Subject Letter of Clarification No. 3 for Fire Station No. 20 Structural Bracing and Wall Construction for the General Services Department

Reference: Bid Inv. No: S50-C23242

PROJECT : FIRE STATION 20
ADDRESS : 6902 NAVIGATION
HOUSTON, TEXAS 77011

SKETCH NO: 01

Entry Panel Layout Guide

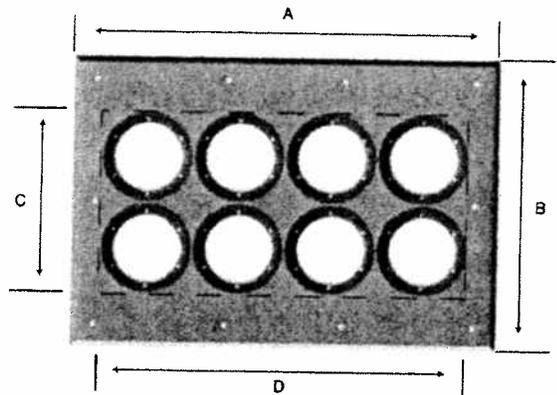
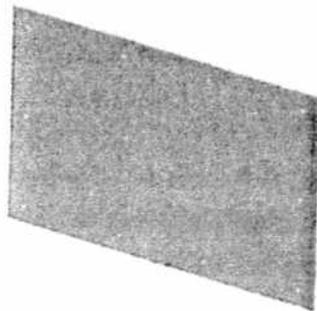
Also attached is a layout guide for the communication cable entry panel that will be mounted on the wall below the area of the antennae masts. The exact location will be determined in the field at time of construction. The entry panel product number is B1905with4-5"ports.

**WALL DETAIL AT
E6 SOTHWEST CORNER**
SCALE: 1/2"=1'-0"

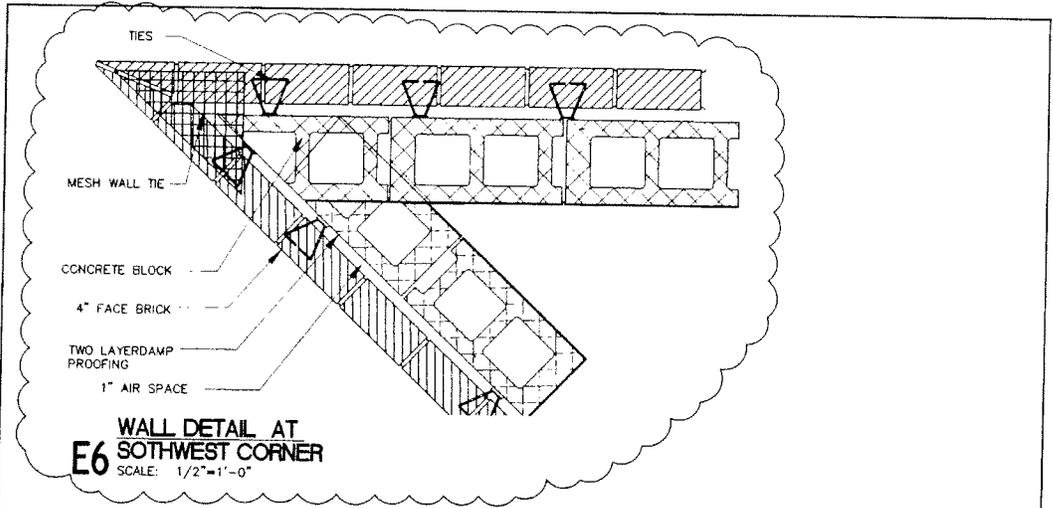
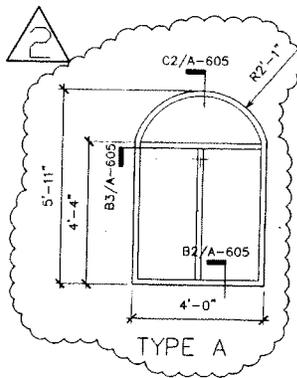
Question: A new detail on the "pointed" brick wall, southwest corner of the building was discussed to eliminate a weak joint.

Question: Please provide a detail for brick work at the corners with angles less than 90 degree. We would like to know if a vertical joint at those locations are permitted or a special brick shall be ordered.

Question: Brick special shaped pieces for angled corners are not in stock and will need to be special ordered. Do we figure on special order or not?

Answer; The contractor shall follow the brick layout as it is shown in sheets A-102 & A-103, for new detail see Sketch 01 of this addendum hereby included. (See attached drawing).

Answer: Detail is shown in Sketch 01 of this addendum hereby included. (See attachment drawing)

Answer; No special order, it can delay completion of the brick work. Re: Sketch 01 of this addendum hereby included for angled corners detail. (See attachment drawing)
